Proposal for Chapter 5 of the Draft ECE R 55 "agricultural couplings"

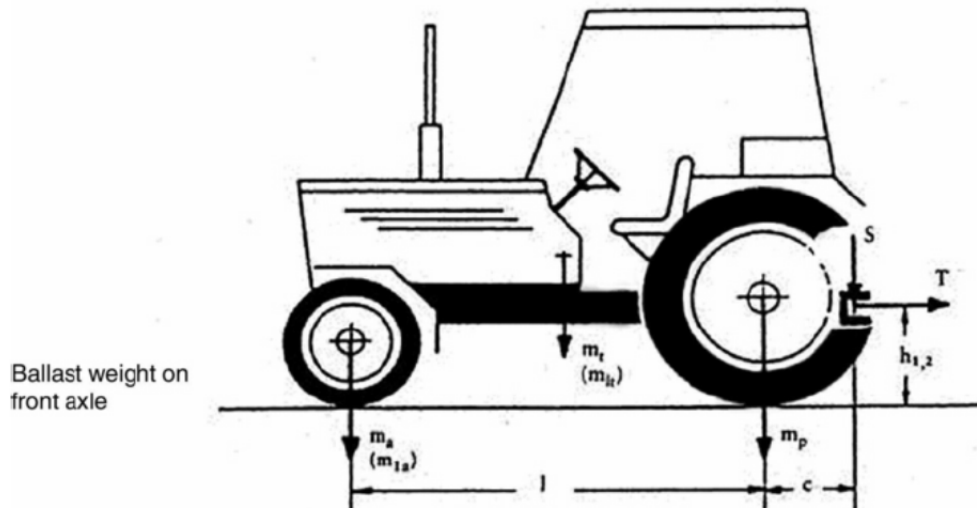
- 5.1 The mechanical coupling device or component fitted to the vehicle shall be approved in accordance with the requirements of paragraphs 3 and 4 and annexes 5 and 6 of this Regulation. This sentence does not make any sense to me. ((= 6.1 of R 55))
- 5.2 Height above the ground of the coupling device (h)

(see figure below).
